GROUP Body	MODEL 2014~2016MY Cadenza (VG)
	NUMBER PS282 (Rev 1, 04/28/2015)	DATE January 2014

SUBJECT: RATTLING, SQUEAKING OR CREAKING NOISES FROM ROOF AREA

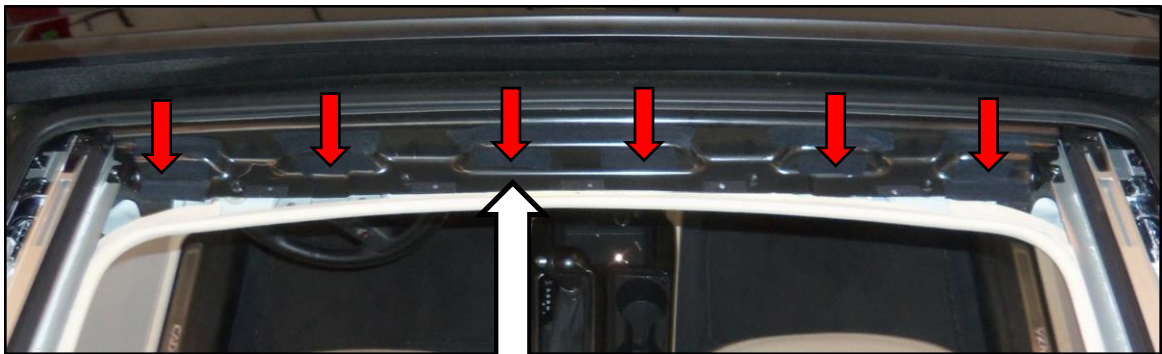
2. Add seven (7) pieces of felt tape along the front of the panoramic sunroof opening in order to isolate the front cover assembly from the body and prevent possible squeaks or rattles.

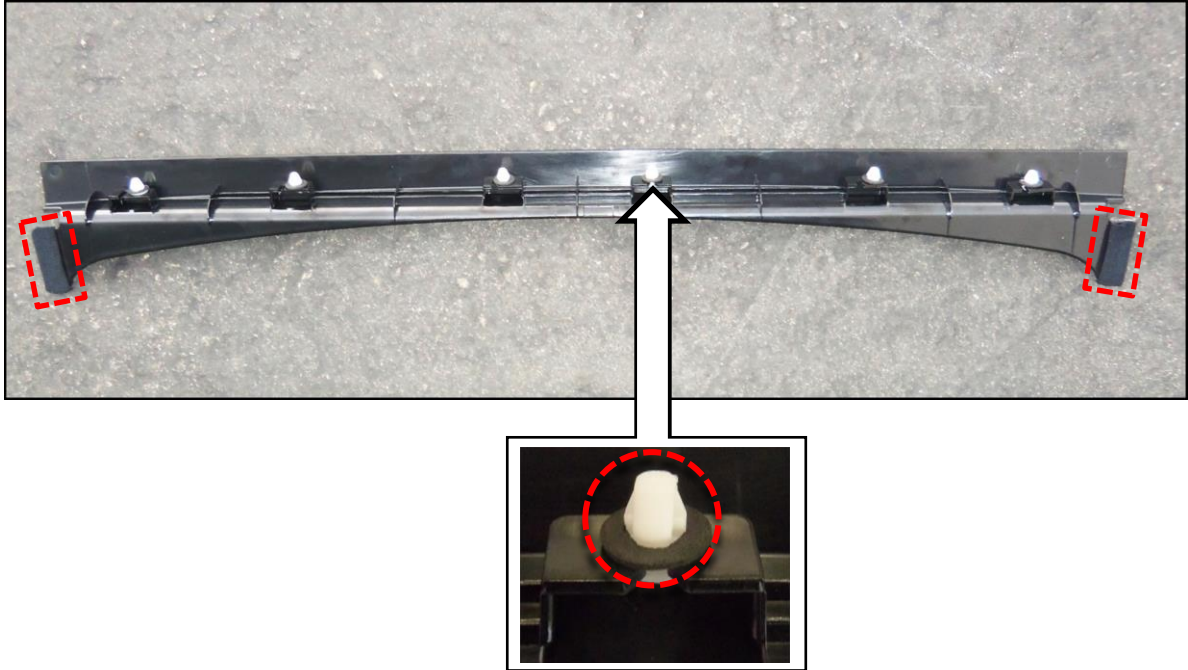
3. Apply six (6) pieces of felt tape over the mounting holes for the front cover assembly. Cut the felt in an "X" pattern at each mounting hole to allow for easy insertion of fasteners.

Service Procedure 2:

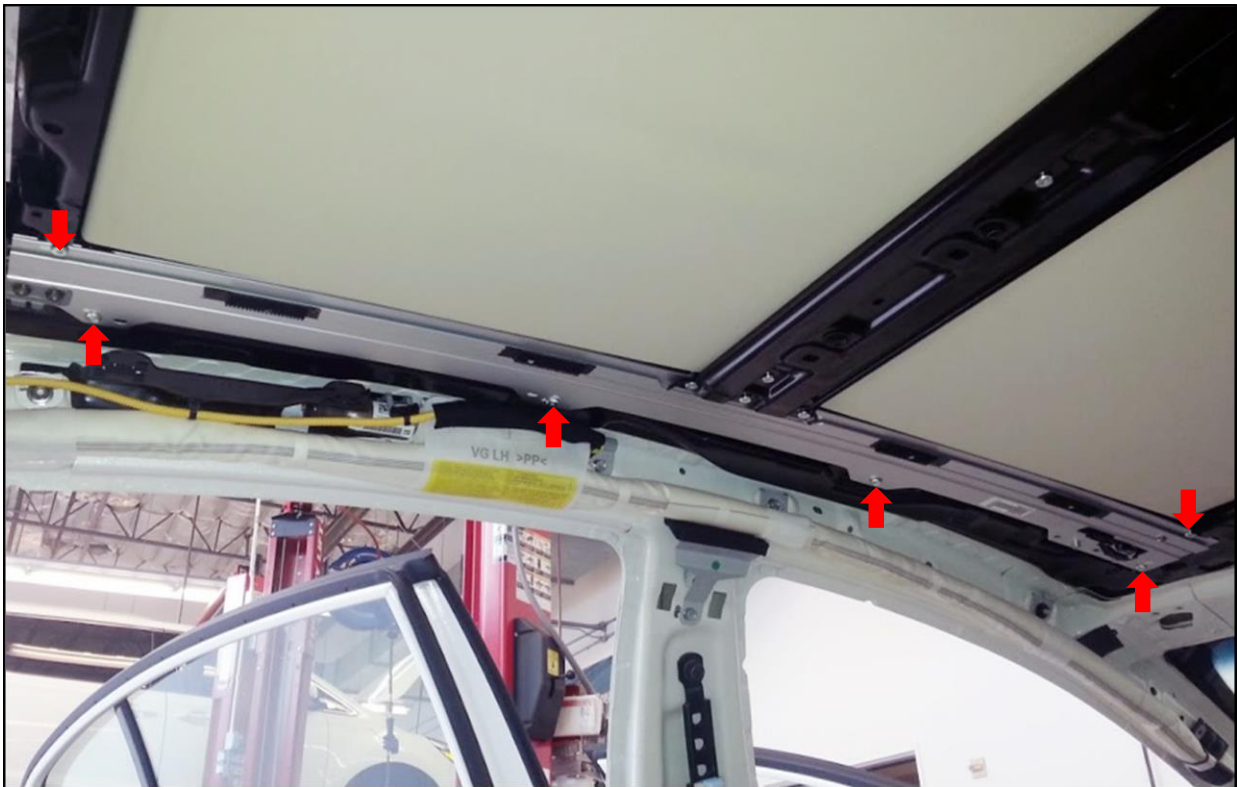
Check for possible loose Torx® head screws in the Panorama Sunroof mounting rails and crossbar. If any bolts are found to be loose, make sure to re-tighten them to specifications.

1. Drop the headliner by referring to the Service Information in KGIS under “roof trim” replacement. **NOTE: Complete removal of the headliner from the vehicle is NOT necessary to perform this procedure.**
2. Fully recline the two front seatbacks to provide more room for the headliner to be lowered and for easier access to the twenty-two (22) Torx head screws. **NOTE: Be very careful when handling the headliner, as it is very susceptible to creasing.**
3. Use an inch-pound torque wrench to properly torque all of the Torx® head screws, as shown below, on the left, right rails and center cross bar of Panorama Sunroof.

Torque specification for the Torx® head screws: 53 in-lbs (4.4 ft-lb, 5.96 Nm) **Note: do NOT over-tighten the screws.**
